Moorebank Precinct West Concept Proposal

*State Significant
Development
Modification Assessment
(SSD 5066 MOD 1)
May 2019*

Figure 5 | Modified Layout

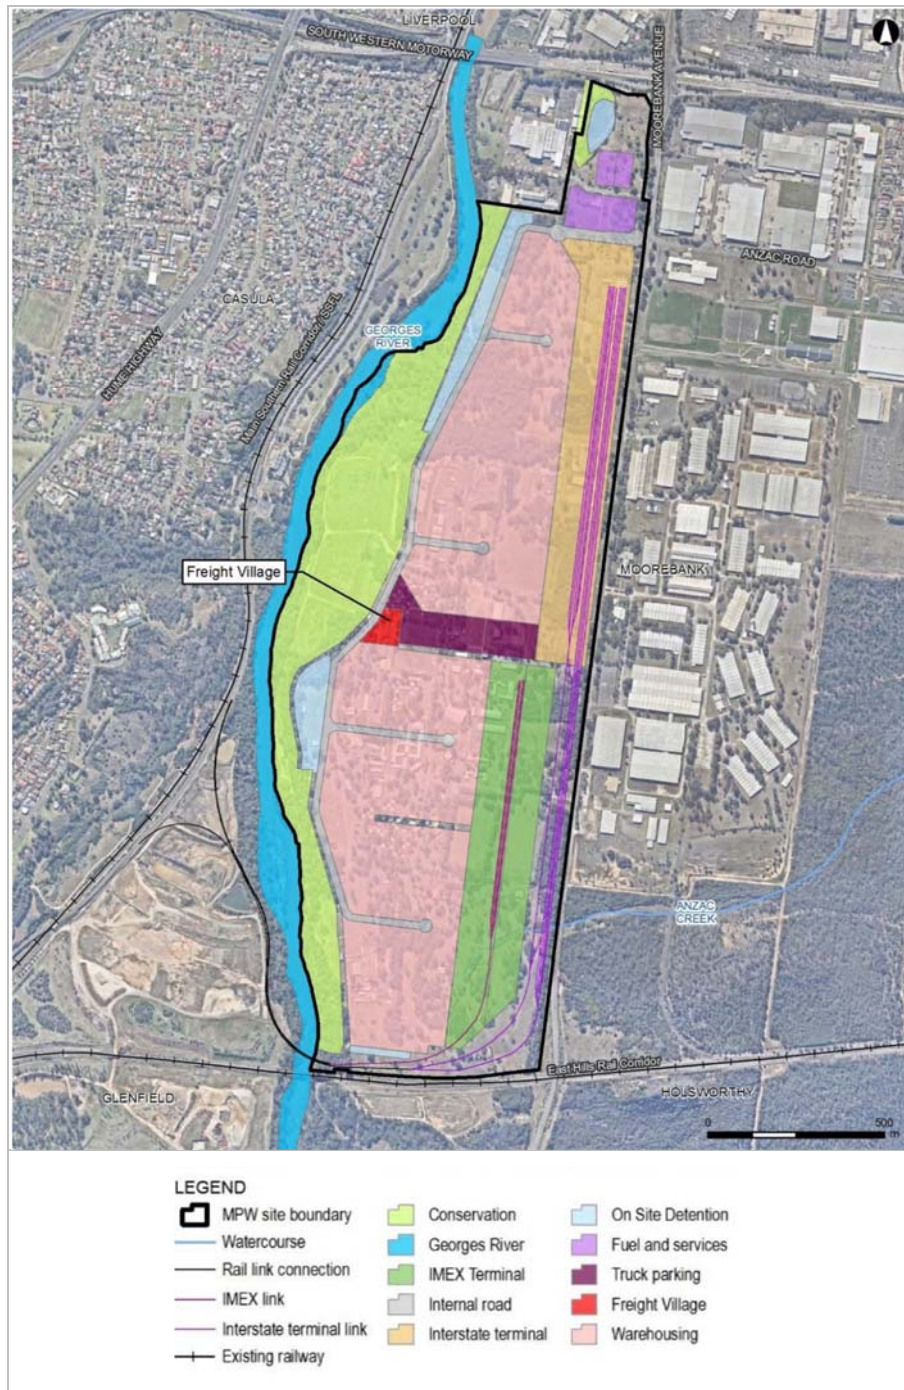
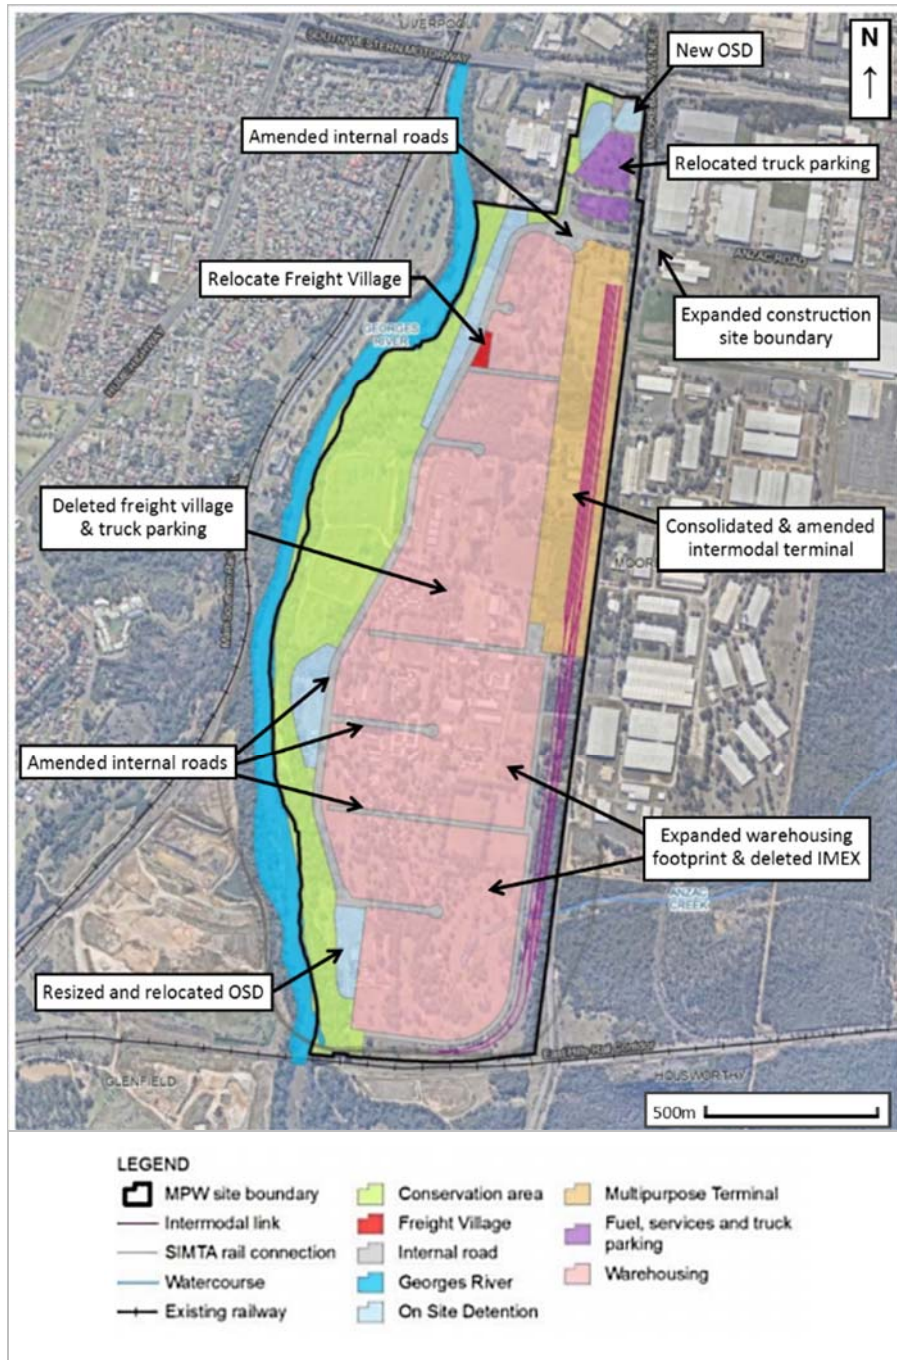
As shown in **Figure 4**, the approved MPW Concept included two IMTs, centrally located freight village and truck parking area and three OSD basins (two adjacent to the conservation area). Note that the northern basin shown in **Figure 4** is existing and is known as Amiens Wetland. **Figure 5** shows the modified layout with one IMT, the freight village and truck parking further to the north, additional OSD basin next to Amiens Wetland and the small rectangular OSD at the southern end of the site replaced with a large OSD basin to the west.

Figure 6 | Proposed Earthworks (source: MPW Stage 2 Consolidated Assessment Clarification Responses 21/12/2018)

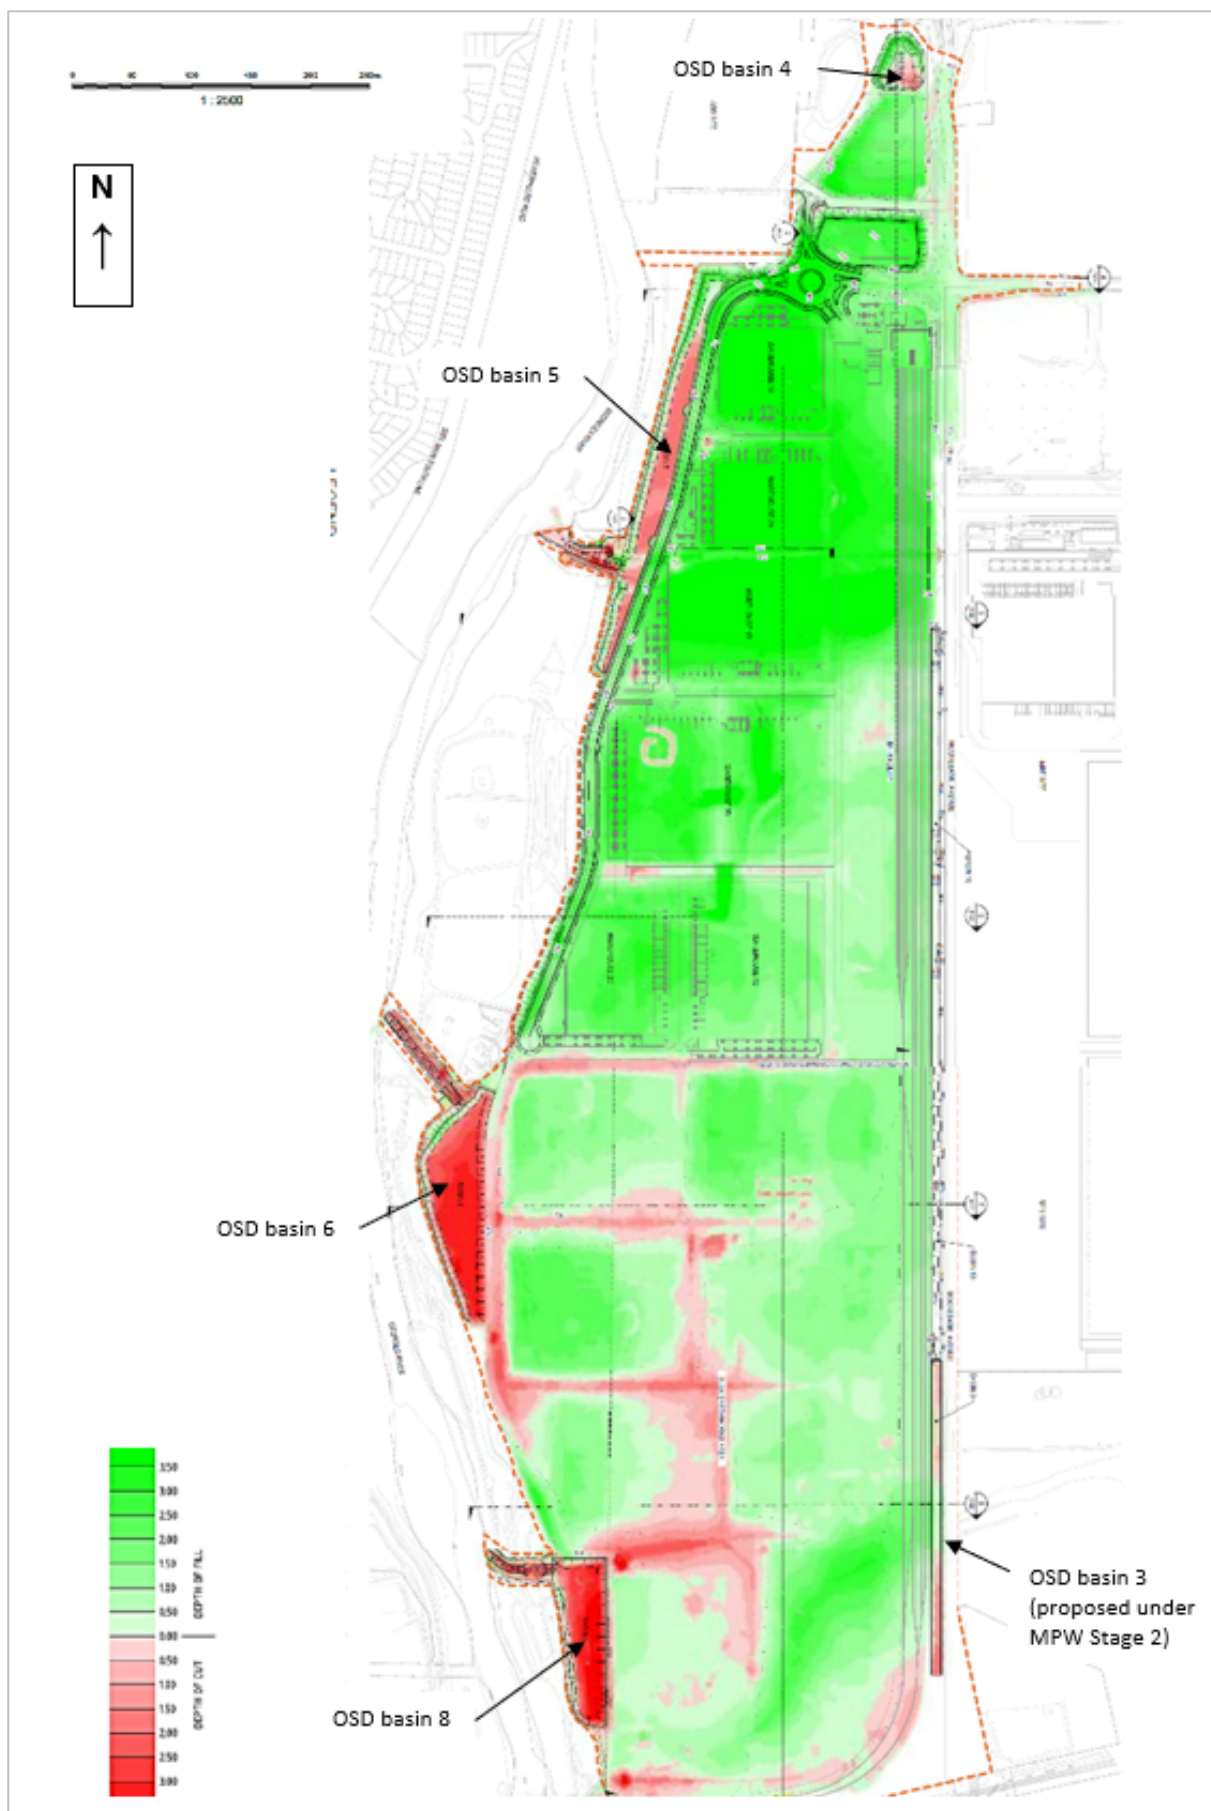
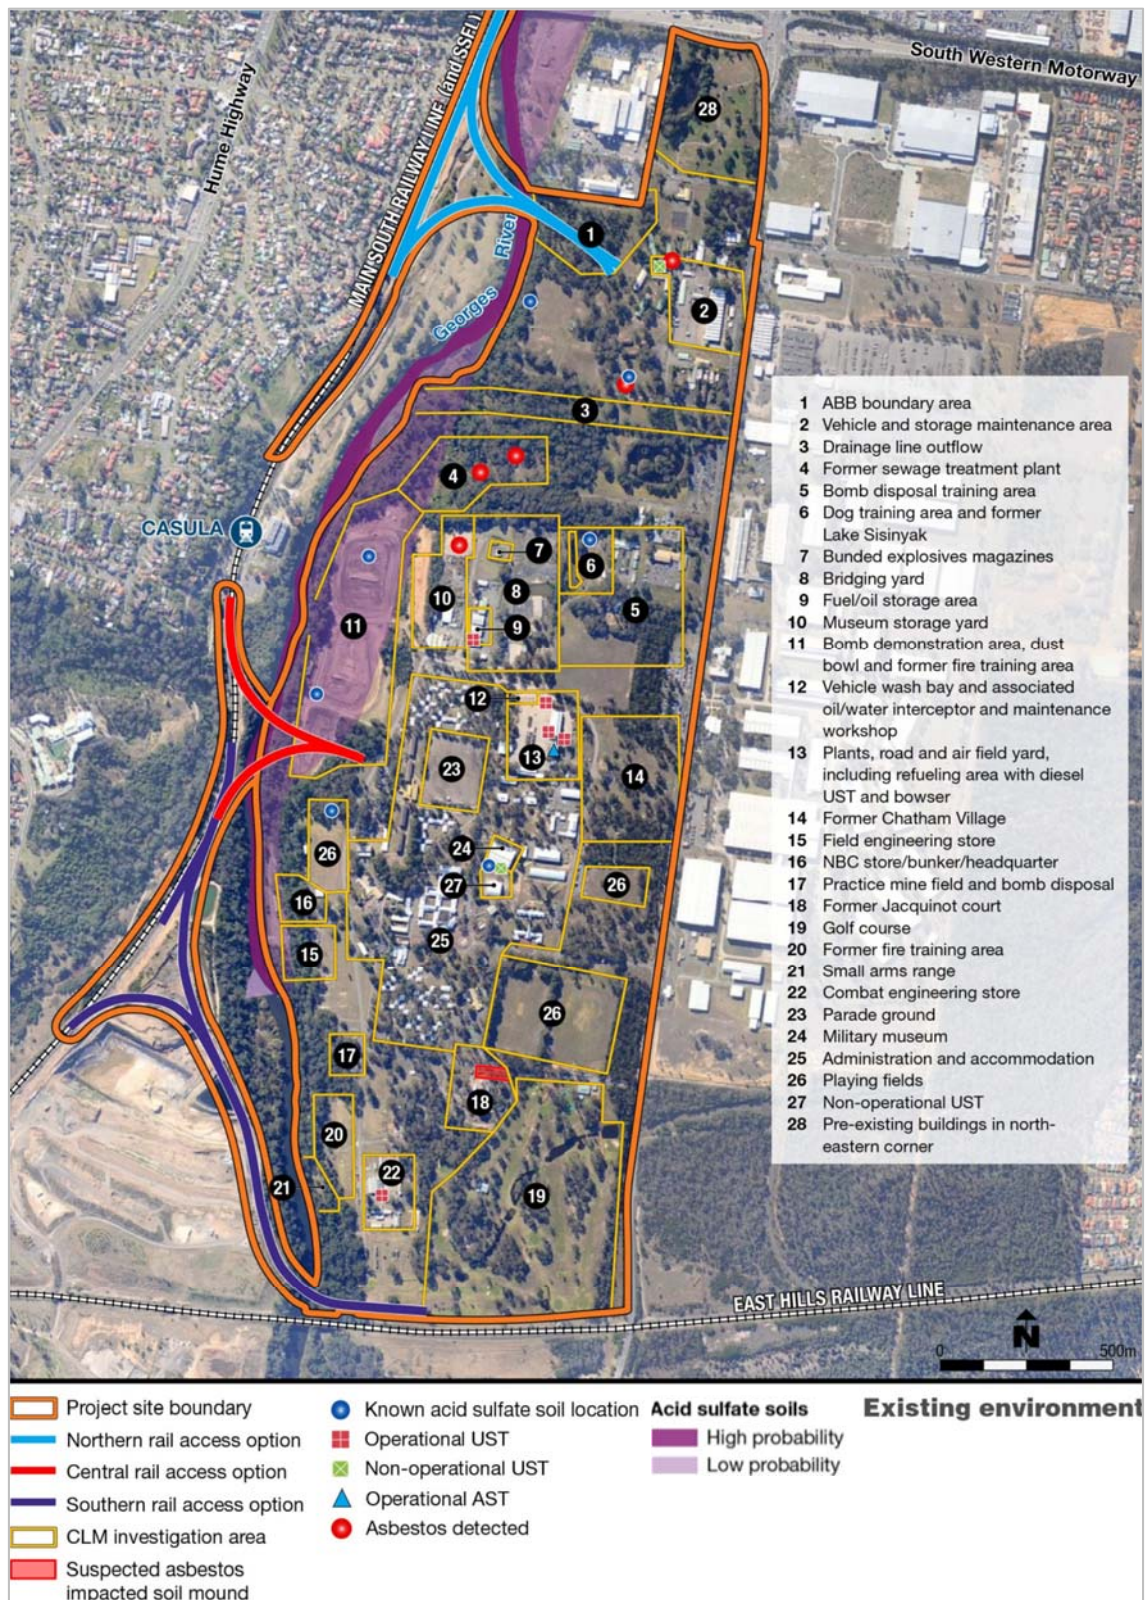
As indicated by the shading in **Figure 6**, the placed fill would result in batters approximately 3 m high adjacent to the ABB site and riparian corridor/ conservation area between proposed OSD basins 5 and 6, and proposed OSD basins 6 and 8. It is unclear whether the layout would provide maintenance access to the toe of the batter within the site (in the case of the batter adjacent to the ABB site) or provide maintenance access without encroaching into the riparian corridor/ conservation area and associated biodiversity offset areas (refer to **Section 6.1.6** for information on offset areas).

The Department considers that there should be no impacts on adjacent lands including biodiversity offset areas and the riparian corridor, that building setbacks should allow for stabilised batters and details should be provided on the design of fill batters to ensure stability, mitigate visual impacts and provide for maintenance access.

The modification proposes fill over the entire development site, generally 2 to 3 m deep. **Figure 6** indicates fill depths as well as areas that would be excavated up to 1 m and up to approximately 3.5 m for the OSD basins.

OEH stated that the location of imported fill should not result in impacts (including indirect impacts) on the biodiversity values of the riparian corridor/ conservation area/ biodiversity offset areas. The Department's recommended conditions relating to the design of fill batters and maintenance access (for MPW Stage 2) and dust, erosion and sedimentation (as discussed in **Section 6.1.4**) would ensure there were no direct or indirect impacts on biodiversity values in these areas.

Figure 10 | Biodiversity Offset Areas (source: MPW Stage 2 BAR dated 20/3/2019)

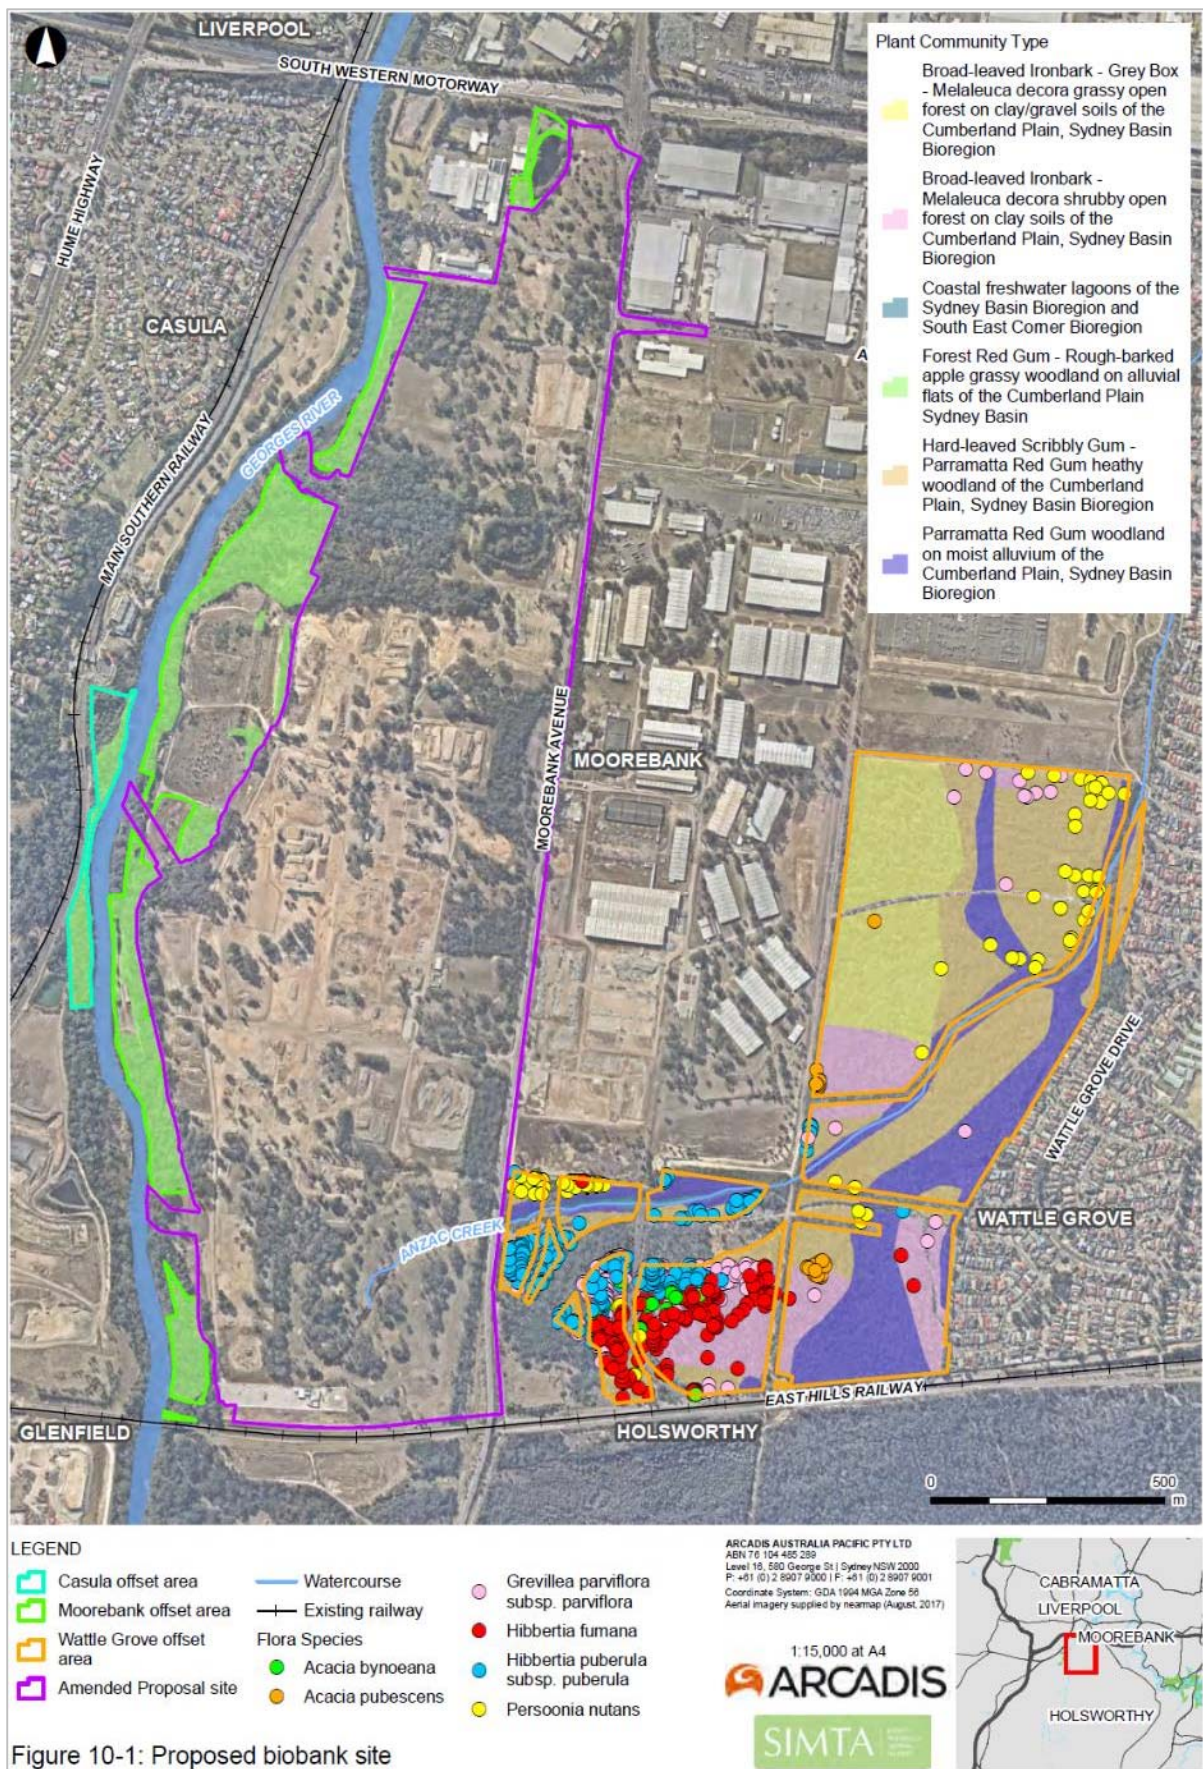
The Department considers that the layout of the site must not prevent provision of vegetated wildlife corridors linking the Georges River riparian corridor and Moorebank offset area, with the Wattle Grove offset area (see **Figure 10**) and recommends a condition to this effect. In line with OEH's recommendation, the Department also recommends a condition that all future development applications include an assessment of the impact of the development on core Koala habitat and provide a detailed assessment of options to minimise impacts.

Figure 13 | Georges River Flood Extents (source: MPW Stage 2 EIS 2016, Stormwater and Flooding Assessment)

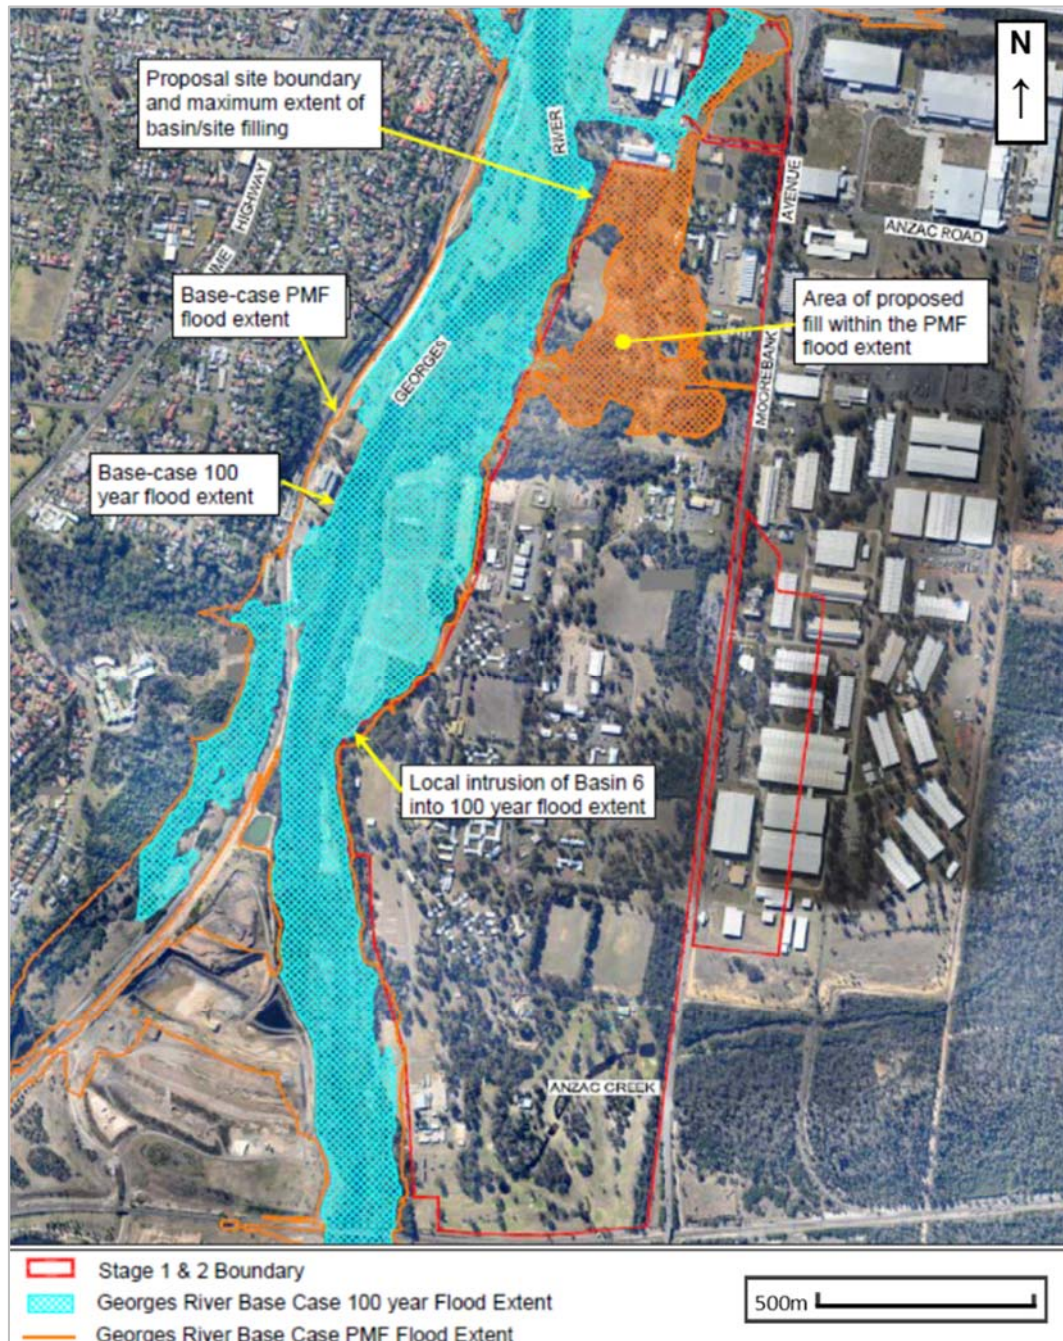
ABB raised concerns about the Applicant's stormwater assessment and potential impacts on its site and operations. Issues identified by ABB included:

- the completeness, accuracy and adequacy of surface stormwater flow modelling
- proposed stormwater drainage works/ management of stormwater both during construction and operation
- effect of drainage construction, altered surface flows, and altered groundwater flows and levels on PCB contamination on the ABB site (and the need for monitoring of PCB contaminated groundwater).

The MOD RtS did not provide an assessment of the impact of raising the site on offsite local stormwater management and flooding. The ABB site would be up to 3 m below the filled MPW site, hence overland flows to the south would be blocked. There is an existing stormwater pipe through the ABB site and, as part of the MPW Stage 2 Application, a new outlet is proposed to the Georges River within the Endeavor Energy easement which is adjacent to the ABB site.
